Timing belt kit

febi no. 14110

fits Vauxhall Corsa B, Tigra A, Astra F 1.4 16V and 1.6 16V, also Vectra B 1.6 16V and 1.8 16V except x 1.8 XE (ref. no. 1606 274)

Vauxhall 5614 430 plan

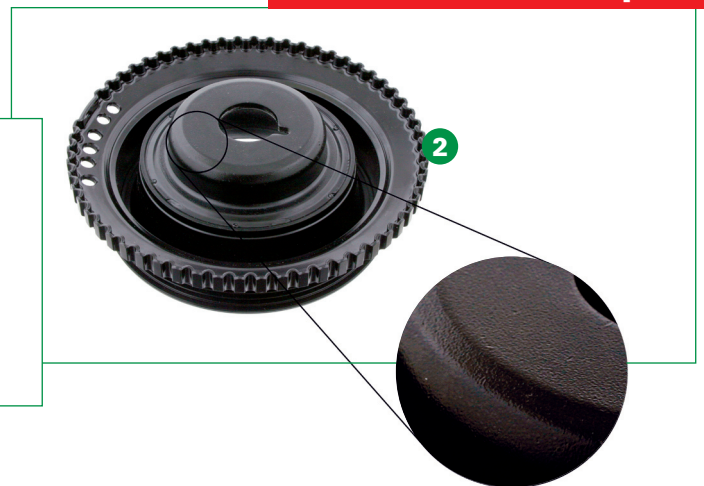
The timing belt can break.

The design of the belt pulley has been changed by the vehicle manufacturer. The slightly raised section of the old belt pulley (refer to picture 1) can cause a faster deterioration of the timing belt edge. This causes the timing belt to move and be prematurely torn, leading to serious engine damage.

Please note: when you replace the belt pulley, the crankshaft gear (refer to picture 3) (Vauxhall 0614 546) and the stretch bolt (refer to picture 4) (0614 932 Torx) should also be replaced.

febi bilstein recommends: before fitting the timing belt kit febi 14110, check for a raised part of the belt pulley and, if necessary, replace with the new version (refer to picture 2) (Vauxhall plan 5614 430). The new belt pulley will fit correctly to the timing belt, thereby guaranteeing a longer life span.
